**NPDES PERMIT FACT SHEET
ADDENDUM**

Application No. PA0027197
APS ID 276152
Authorization ID 1032943

Applicant Name	<u>Capital Region Water</u>	Facility Name	<u>Harrisburg Advanced Wastewater Treatment Facility</u>
Applicant Address	<u>3003 N Front Street</u> <u>Harrisburg, PA 17110-1224</u>	Facility Address	<u>1662 S Cameron Street</u> <u>Harrisburg, PA 17104-3145</u>
Applicant Contact	<u>Claire Maulhardt</u>	Facility Contact	<u>Jess Rosentel</u>
Applicant Phone	<u>(717) 216-5255</u>	Facility Phone	<u>(717) 736-9742</u>
Client ID	<u>43333</u>	Site ID	<u>454377</u>
SIC Code	<u>4952</u>	Municipality	<u>Harrisburg City</u>
SIC Description	<u>Trans. & Utilities - Sewerage Systems</u>	County	<u>Dauphin</u>
Date Published in PA Bulletin	<u>December 2, 2023</u>	EPA Waived?	<u>No</u>
Comment Period End Date	<u>January 2, 2023</u>	If No, Reason	<u>Major Sewage w/ CSO</u>
Purpose of Application	<u>NPDES Renewal</u>

RE: Comments of Capital Region Water on Draft NPDES Permit – Sewage
Harrisburg Advanced Wastewater Treatment Facility
Application No. PA0027197; Authorization ID No. 1032943
Harrisburg City, Dauphin County

Figure 1 – Location of CRW's AWTF and Three Mile Island

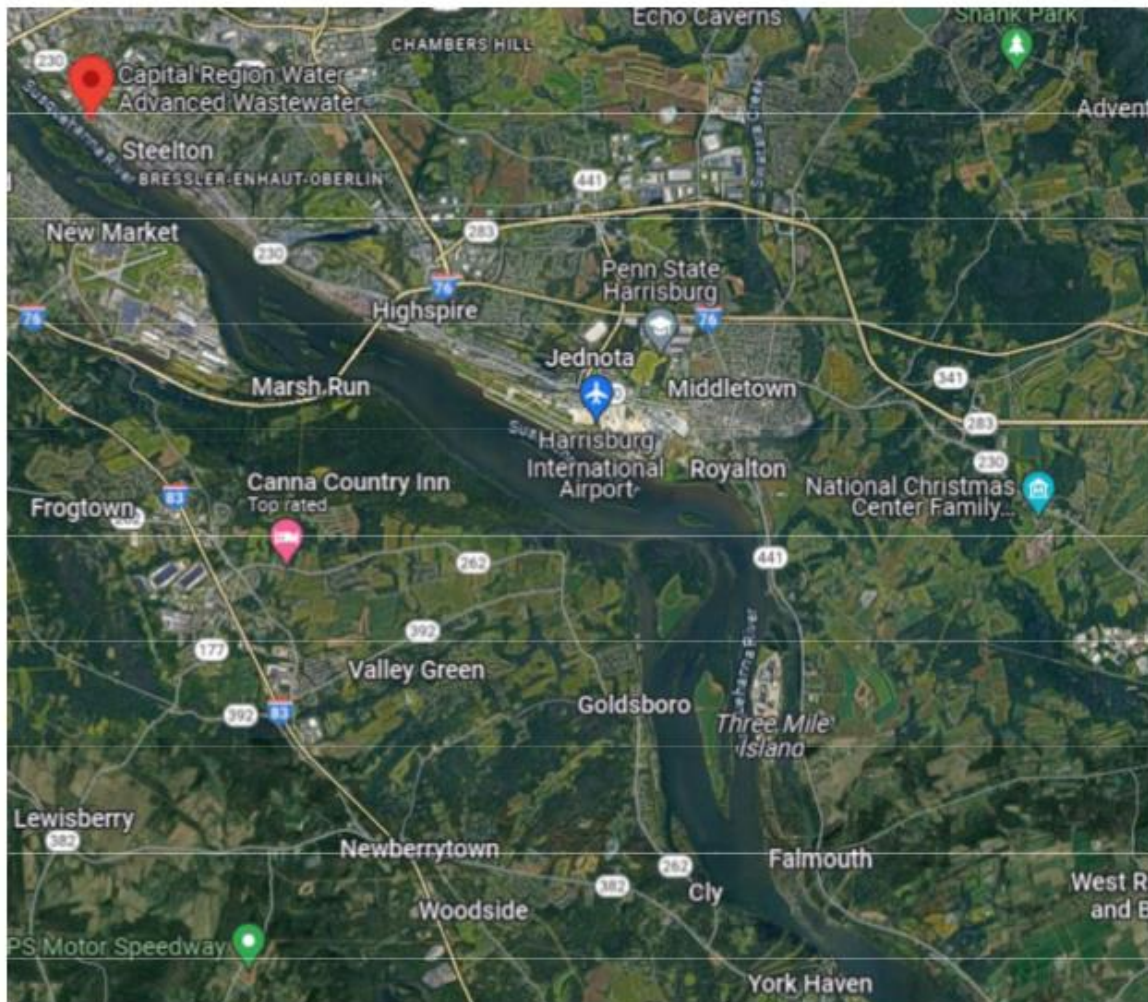
Since the distance to complete lateral mixing needs to be close to 4,000 miles to match the partial mix factors cited in DEP's Fact Sheet, DEP's assumptions are clearly unreasonable and cannot be used to assess the lateral mixing extent in the 15-minute and 12-hour durations associated with the acute and chronic effluent limits. While there is uncertainty in the extent of lateral mixing in the Susquehanna River downstream of the AWTF outfall, complete lateral mixing is likely to occur by Three Mile Island due to the large bend in the river and the downstream hydroelectric plant (**Figure 1**), far closer than 4,000 miles.

- The islands in the river limit the width and flow available for mixing, especially for the 15-minute mixing time associated with the acute partial mix factor. The use of the full river width and flow is overly conservative in this case.

Based on this assessment, significant additional dilution is occurring that is not represented in PADEP's calculations of the proposed TRC limits. Use of inappropriate partial dilution factors likely resulted in proposed TRC limits that are more stringent than necessary considering the configuration of CRW's diffused discharge and the physical conditions present in the Susquehanna River. CRW requests that DEP recalculate the partial and complete mix factors using methods that address the technical concerns identified by CRW, and that those calculations be supplied to CRW for review before the Draft Permit is finalized.

Based on the comments received from the permittee (Capital Region Water), the Department has determined to provide the permittee an opportunity to conduct a site-specific study that would include a site-specific dilution study, evaluation of the best available technologies and selection of technology. The permittee requested 22 months as the interim period to conduct the study. The Department has determined that this request is reasonable and therefore, the new WQBELs will be in effect 22 months after issuance of the permit IF the Department's Water Quality Model (i.e., TRC_CALC spreadsheet) using their study results still shows that new WQBELs listed in the November 13, 2023 draft permit are still needed. Therefore, the following compliance schedule will be provided in Part C of the permit.
